## Aquifer Test Technical Review

From: John Seaberg, PG, Groundwater Specialist

Subject: 2020-2578, Riverview Dairy, Twelvemile

Figure 9. Long-Term Water Level Recovery in Well OW-1

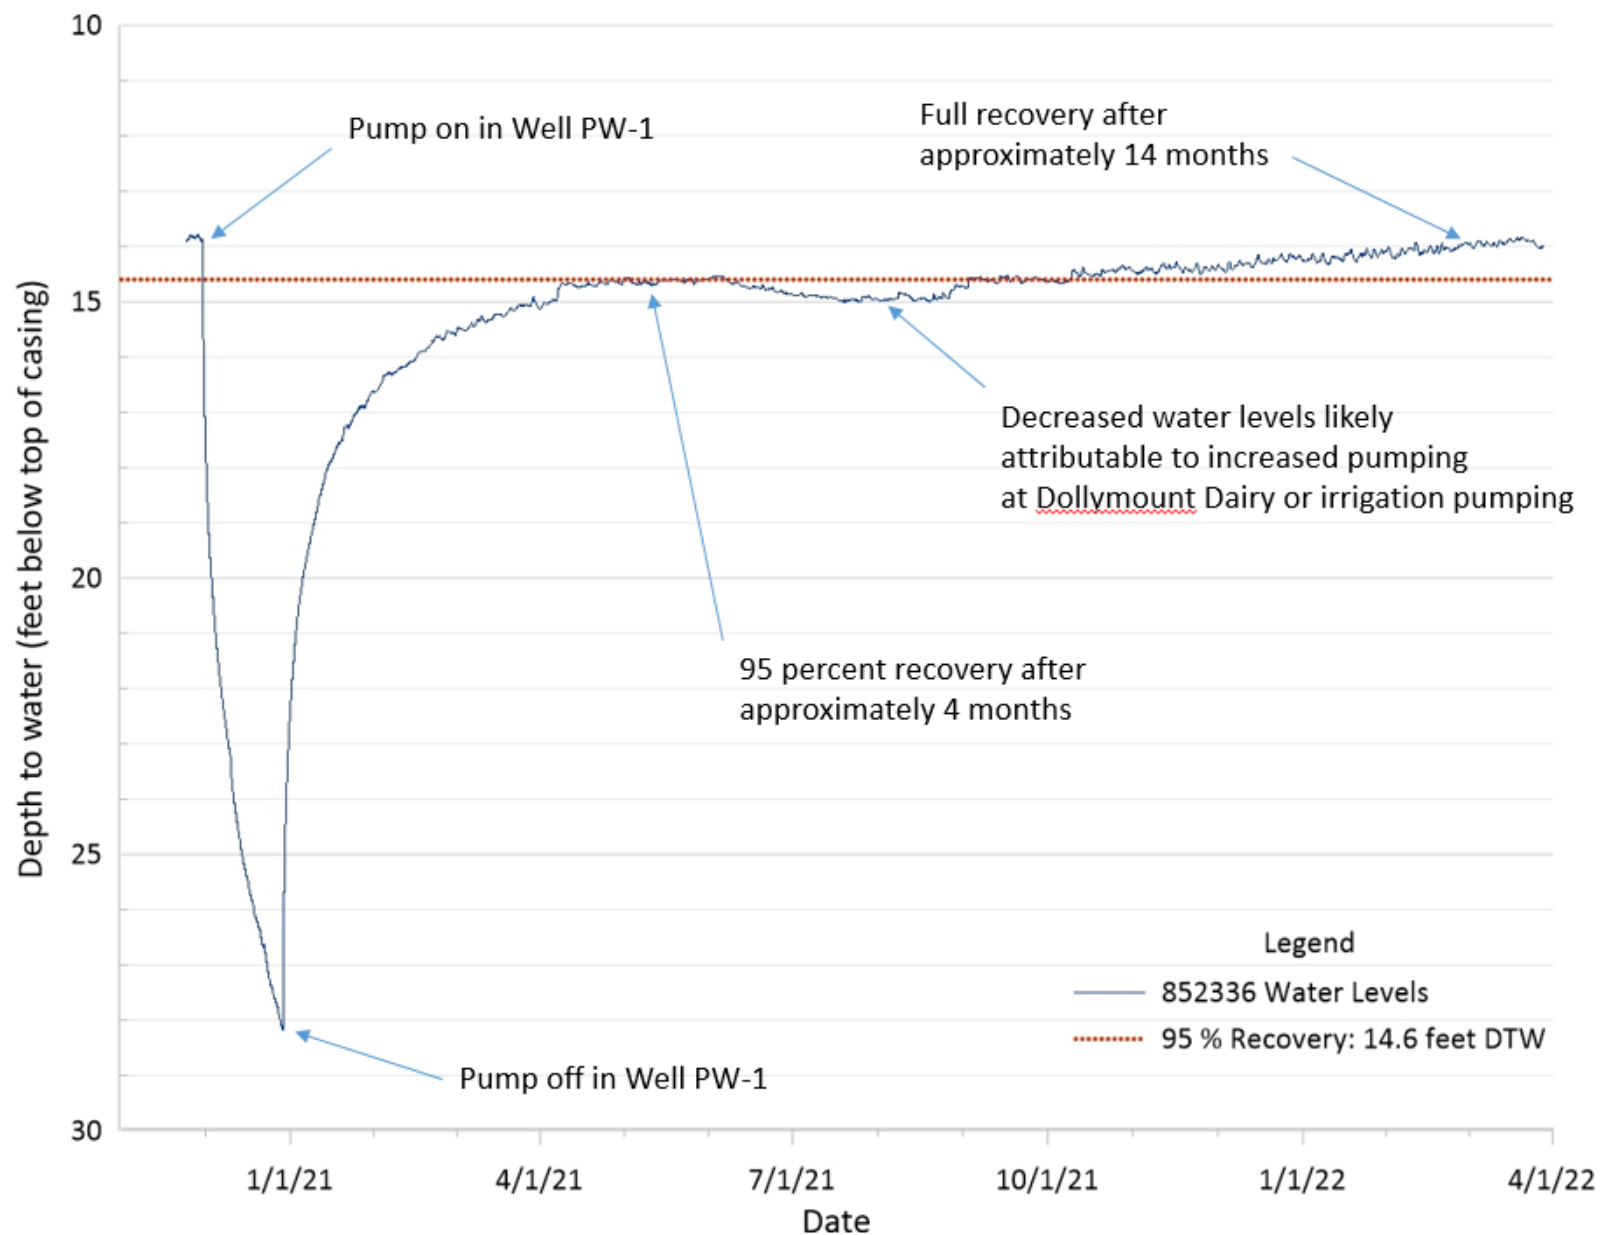
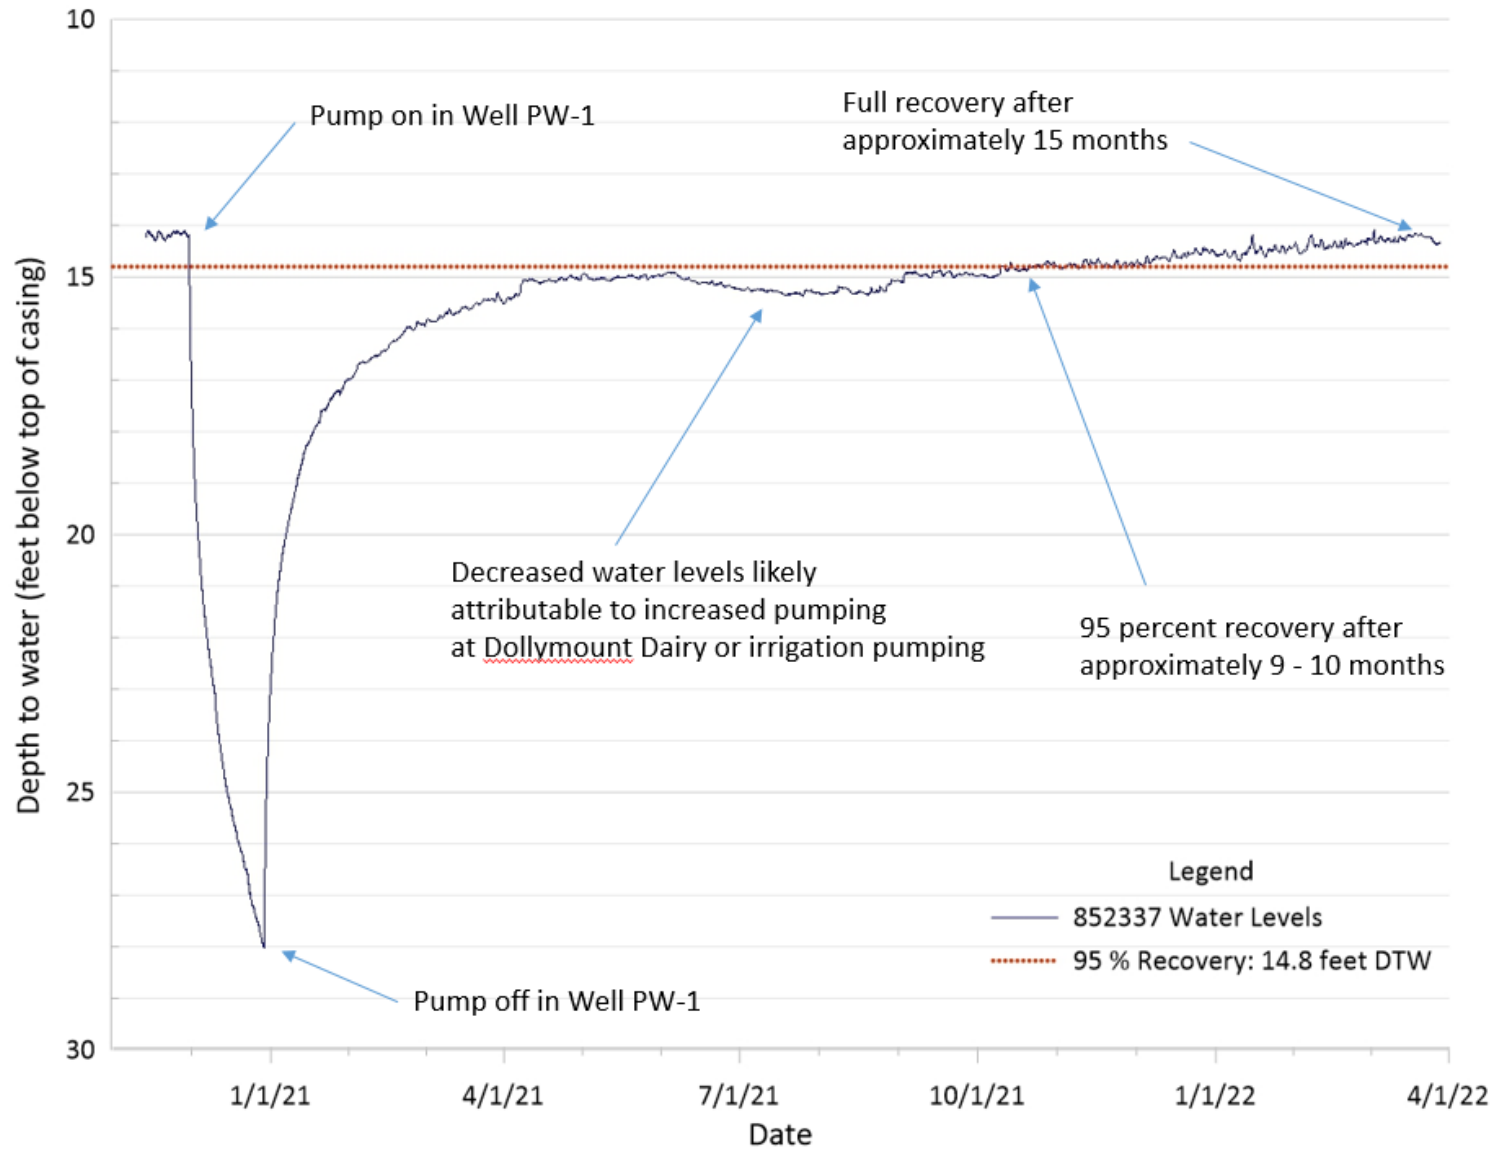
Typically, DNR requires that monitoring of the recovery phase be continued for a duration as long as the pump was on or until water levels in all monitored wells recover 95 percent, whichever is longer. As indicated in Table 5, none of the wells were monitored for more than 29 days after the pump was shut down during the aquifer test. DNR requested subsequent water level data from the Applicant to be able to better evaluate the nature of aquifer recovery, which is an indicator of recharge occurring to the aquifer. Long-term data were provided only for Observation Wells OW-1 and OW-2. Water level data, plotted as depth to water, for Wells OW-1 and OW-2 from before the beginning of the aquifer test through March 28, 2022, are presented in Figures 9 and 10, respectively. Figure 9 show that water levels in the deep Cretaceous aquifer took approximately 4 months to achieve 95 percent recovery, and Figure 10 shows that water levels in the overlying QBAA took approximately 9 to 10 months to reach 95 percent recovery. Recovery times are summarized in Table 6. Water levels in both wells experienced a slight downward deflection during the summer of 2021, which is likely attributable to increased water use at the nearby Dollymount Dairy or irrigation demand. However, full water level recovery did not occur in either well until over an entire year had elapsed, indicating that recharge is very limited and not likely to be sufficient to sustain long-term operation of the proposed facility.

**Figure 11. Domestic Wells within 2.5 Miles of Production Well PW-1**

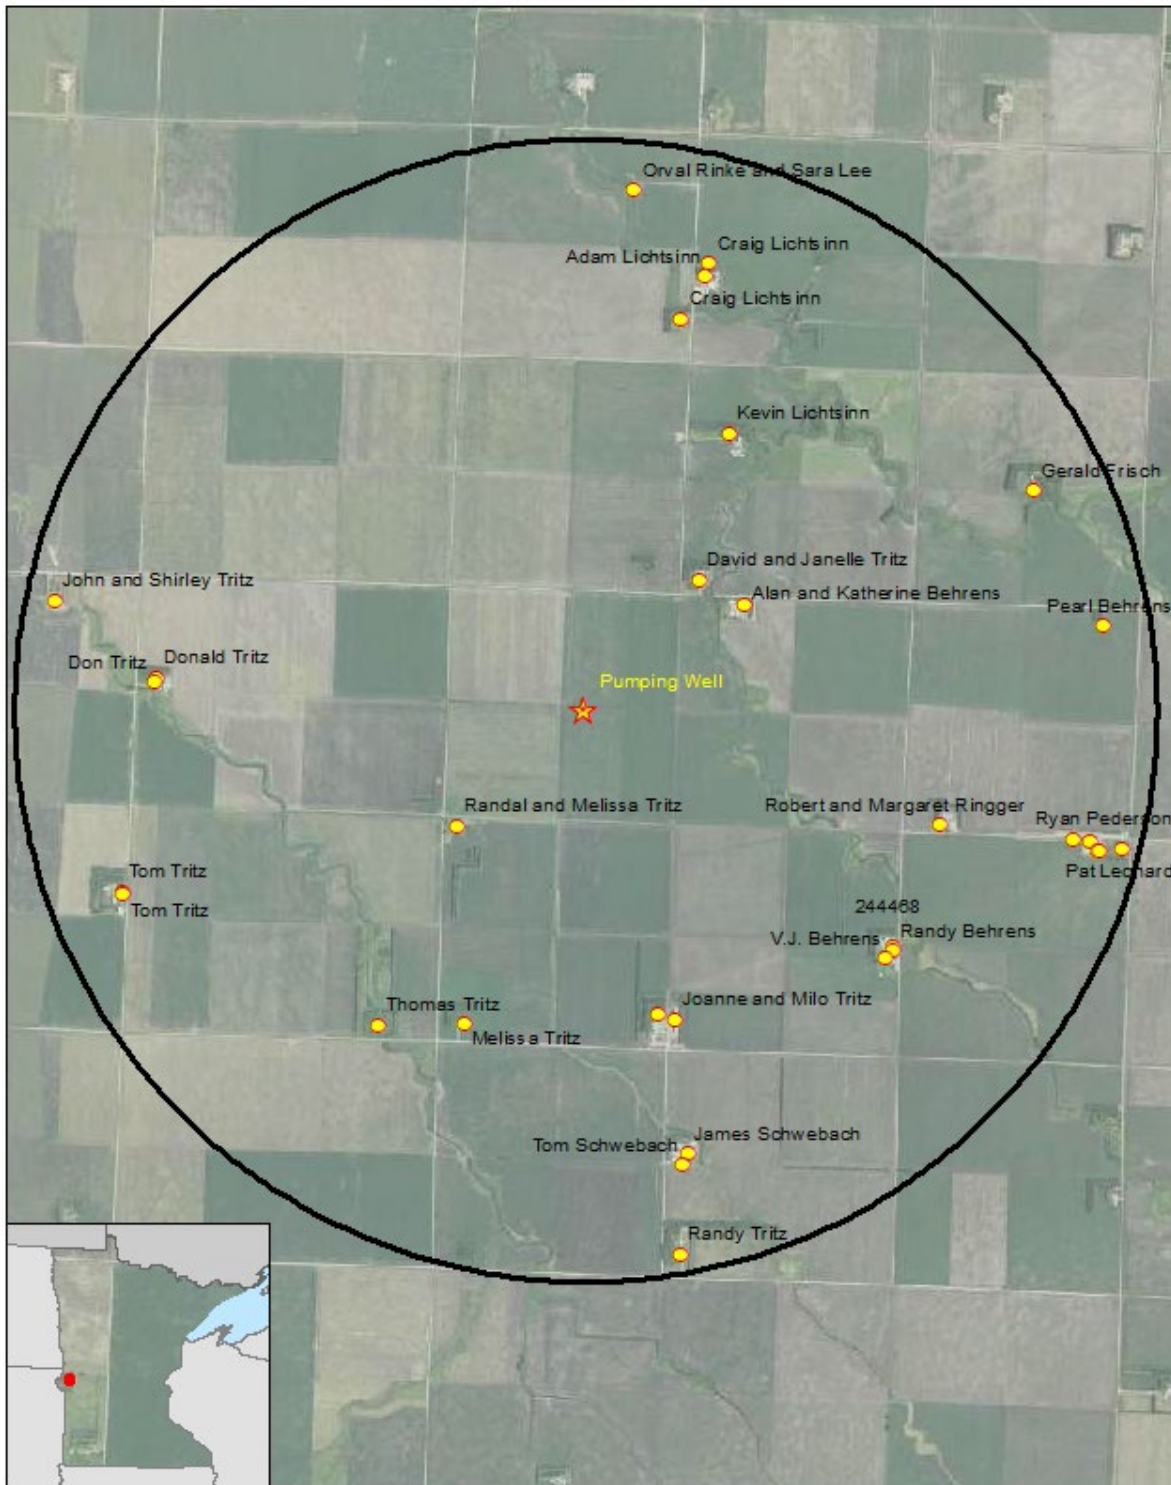
Table 7 of the Aquifer Test Report (LRE Water, 2021) identified 19 private domestic wells within 2 miles of Production Well PW-1, and appears to be complete. Given that significant drawdown was observed during the aquifer test at a distance of over 1.6 miles away, DNR expanded the radius around Well PW-2 to 2.5 miles to evaluate the risk of domestic well interference for evaluating domestic well interference at the proposed Twelvemile site. This approach, which is also consistent with that used by Walker (2019) for the Dollymount site, resulted in the identification of 32 wells, as listed in Table 7 (placed after the text of this report due to its size) and shown on Figure 11.

Based in this worst-case scenario of drawdown of 38 feet, 16 of the 30 wells within 2.5 miles of Pumping Well PW-1 do not appear to be at risk of going out of water during 30 years of pumping at the proposed facility. One well was determined to have a moderate risk of going out of water, and four wells were determined to be at high risk. Risk for the remaining nine wells could not be determined. These wells should be inspected to determine 1) whether they have been abandoned, and, if not, 2) the height of the column of water above the pump.

5. A licensed well contractor should lower the pumps in the four wells determined to have the highest potential of going out of water during facility operation;

6. The nine private domestic wells lacking construction information should be inspected by a licensed well contractor to determine 1) the height of the column of water above the pump, or 2) whether they have been abandoned.
